**Draft Determination
Review of the System Restart Standard
Submission**

Draft Determination Review of the System Restart Standard

A Submission to Reliability Panel AEMC

October 2016

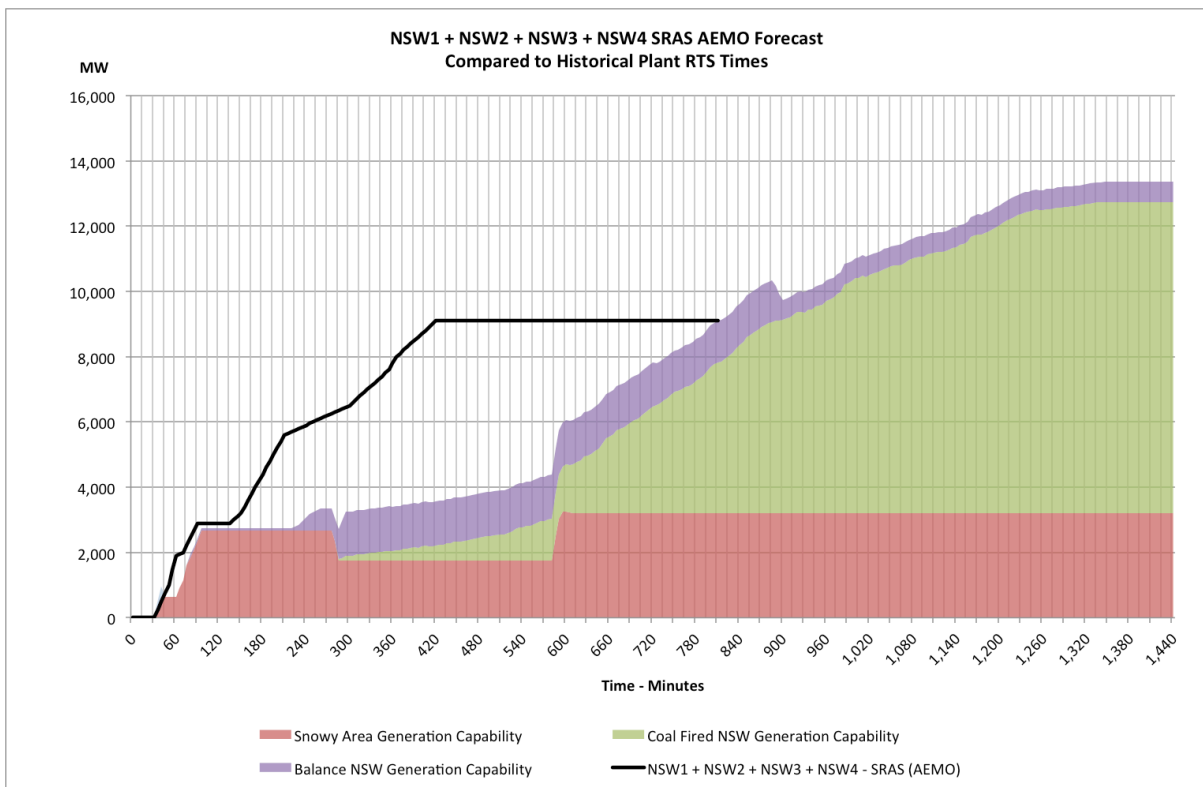
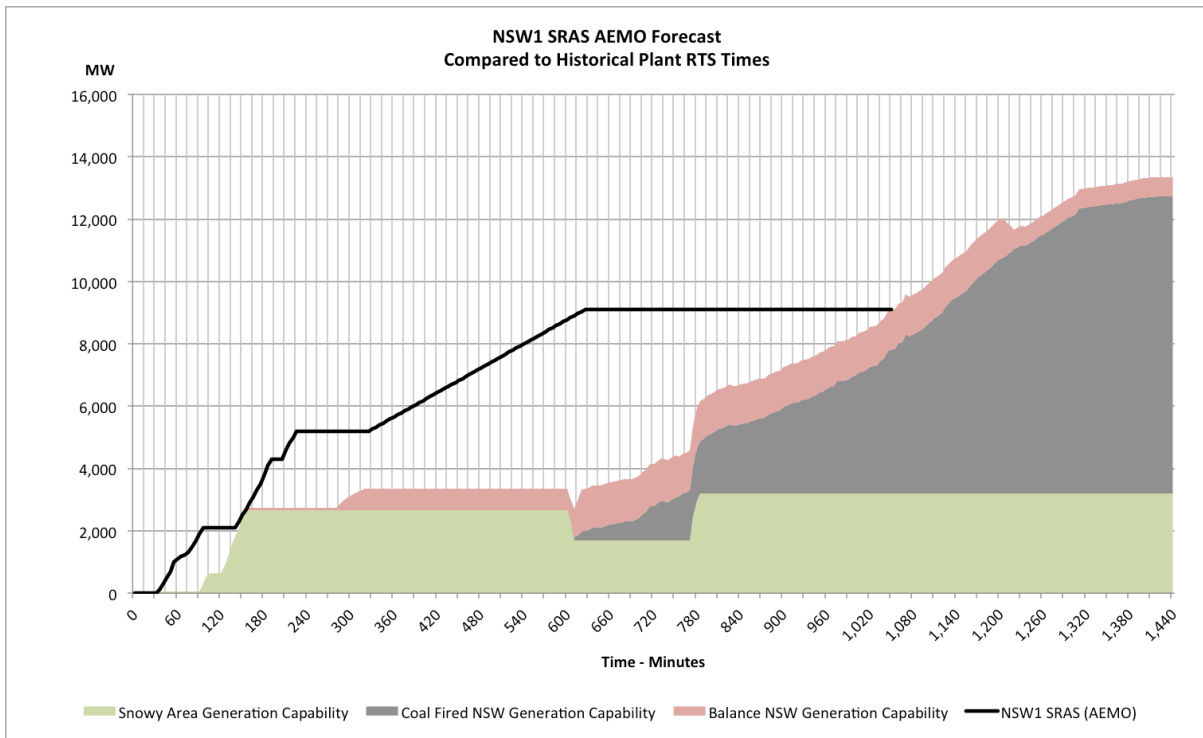
The graphs comparing our restoration curves with those prepared by AEMO are shown below. It is important to note that both curves are available generator capacity. This is because the historical data is derived from circumstances where all the available capacity was fully dispatched by displacing existing higher priced generation without any limitations imposed by the transmission system.

From these comparisons it appears that the restoration curves used in the Draft Determination are quite optimistic compared to historical experience.

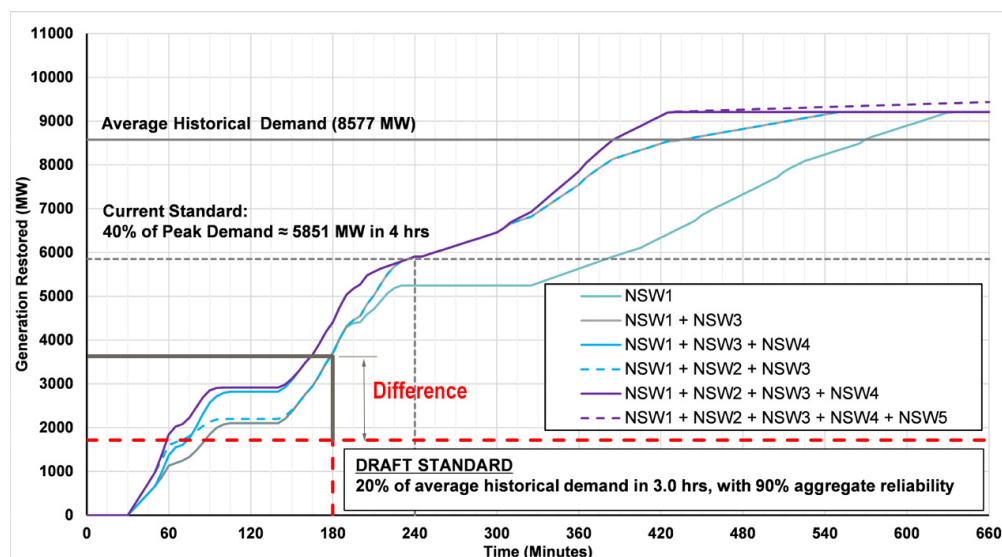
Referring to Figure 6.5 in the Draft Determination it would appear that the Draft Standard is a significant reduction from the current standard. This Figure is reproduced below.

On the basis that the NSW1 + NSW2 line on this graph represents the expected outcome of the current SRAS procured by AEMO. AEMO would have procured this level of SRAS for NSW on the basis that it satisfied the current standard of 40% of peak demand in 4 hours. That being the case the equivalent demand at 3 hours would be approximately 3,800 MW or 44% of average historical demand and not 20% as proposed for the new SRS. The difference is as shown on the graph below.

Given the broad concern by market participants about the adequacy of the current SRAS arrangements it is troubling to see the standard further reduced.

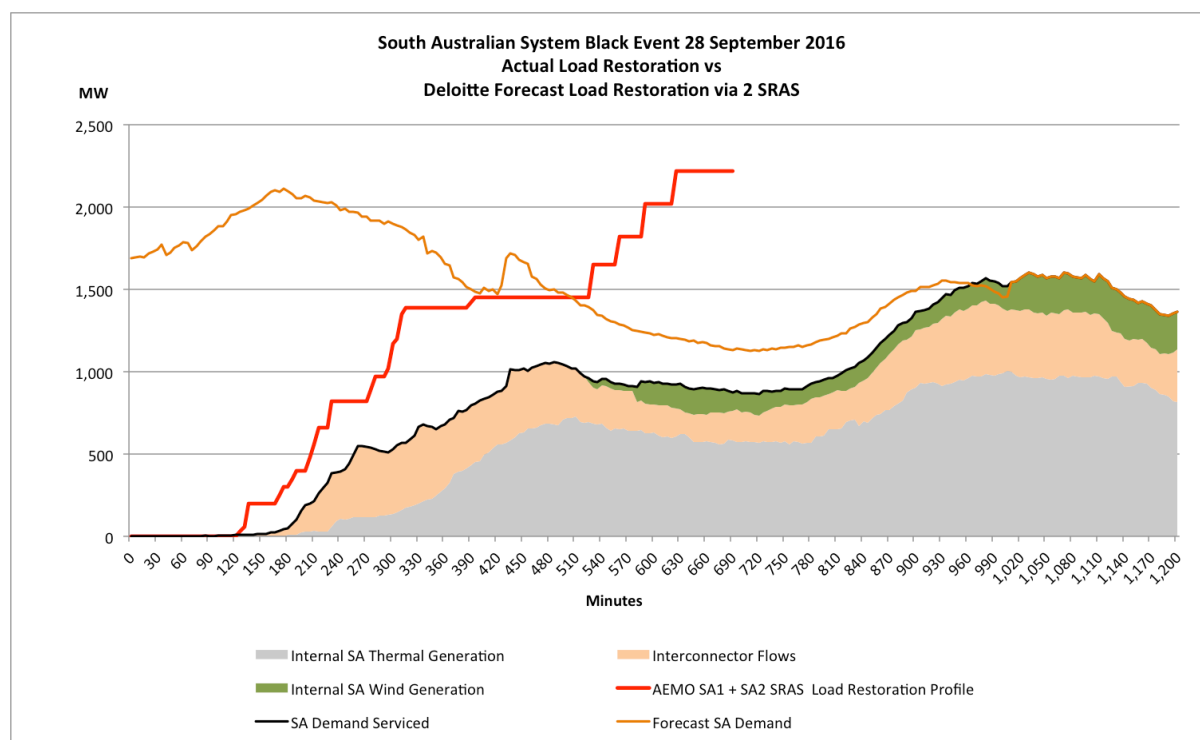
2. We understand that a previous supplier of SRAS was directed by AEMO to attempt to provide a SRAS service. However this was not possible, as the provider no longer possessed this capability. This reinforces the concerns we raised about the use of AEMO directions in our initial submission to the Reliability Panel.
3. The generator restoration timing was significantly slower than that assumed in the Draft Determination for South Australia. This is demonstrated in the following graph.
